INFORMATION NOTE

N° 024/14

Implementation of a close dambar leadframe design for TLE7234SE

Description of Change:

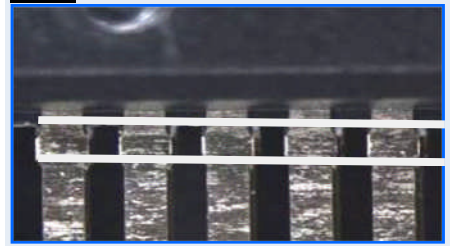
Subject of Change: Change of leadframe design to a close dambar design.

Reason of Change: Harmonization of leadframes.

Assessment: No impact on electrical parameters.
No impact for pick and place at board assembly expected.
